**REMARKS**

**AMENDMENT UNDER 37 C.F.R. § 1.111**

U.S. Application No. 10/650,193

**Q77191**

*Fig. 1D* PRIOR ART

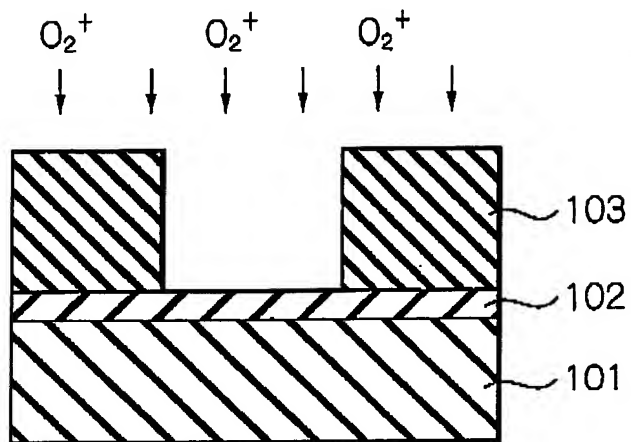
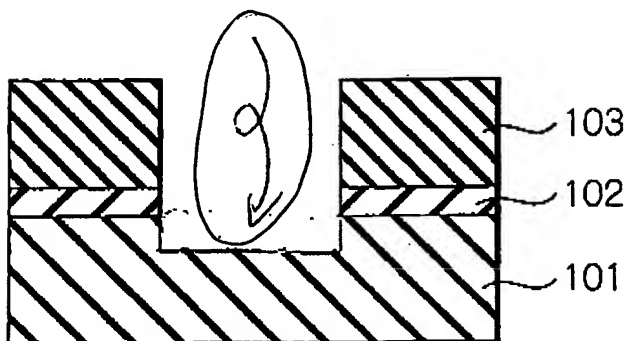
Please replace the drawing sheets numbered 2/87 and 21/87 with the concurrently attached replacement sheets. The annotated sheets indicate that Figs. 1D and 5D of the prior art are amended to each include a swirling arrow, which indicates that the etching stopper 102 is etched back by a dry etching process, followed by a wet stripping process performed upon the insulating interlayer 103 and the insulating interlayer 101, so that residues of the dry etching process are completely removed (see page 8, lines 7-11).
